Sony Corporation

No. PMWM17-086R

Technical Memo

Subject: Part Change Info. [Pipe Lock Knob, Improved Reliability of Screw]

<Reference>

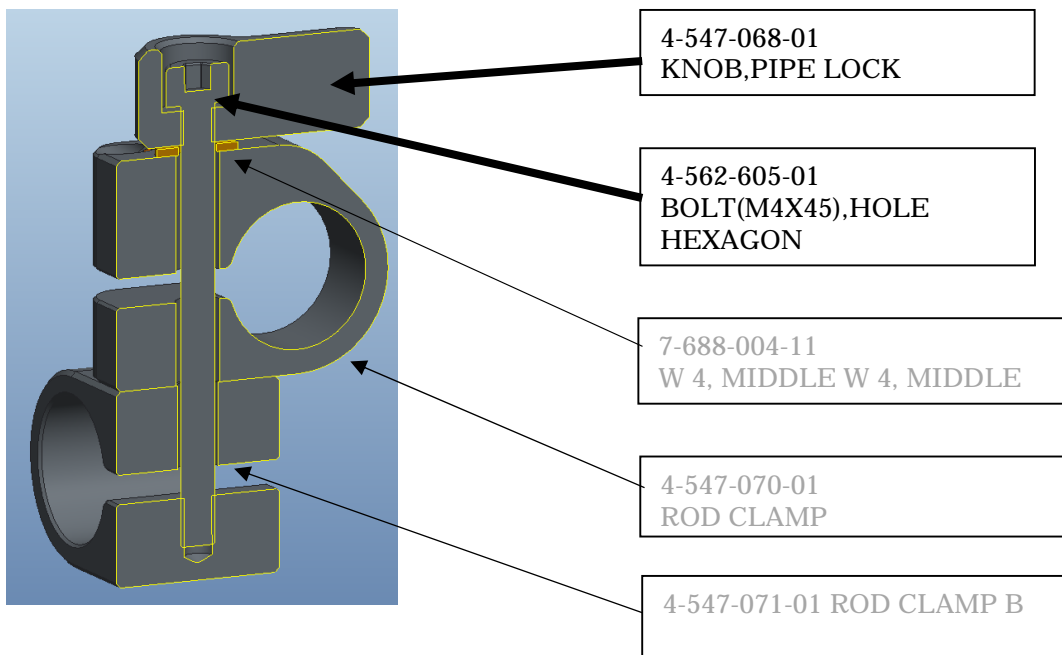
The parts in the blue frame are changed so that the reliability of the screw part of the mechanism of the pipe lock (as shown in the red frame) would be improved and they are registered as the service parts.

The above parts are the ones what the HANARL (dry type lubricant) is applied to the conventional Pipe lock knob and Hole hexagon bolt (M4x45).

When replacing either of two parts, replace both of them to new parts at the same time.

(Old) KNOB,PIPE LOCK 4-547-068-01
 (New) KNOB ASSY (SVC), PIPE LOCK A-2196-367-A

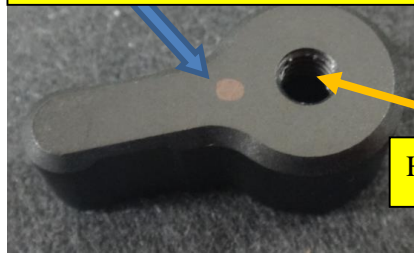
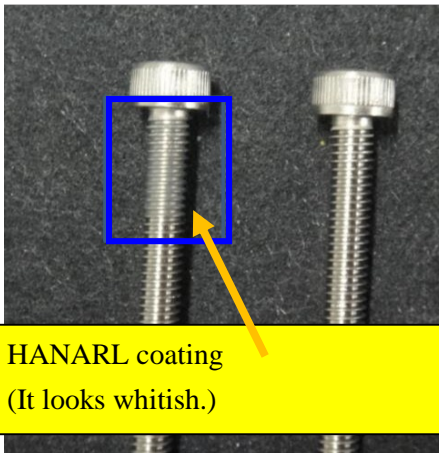
HANARL coating (internal thread)

HANARL is applied to the internal thread.

There is black marking on the smooth surface. Though it is difficult to see, but it is discriminable by the reflected light.
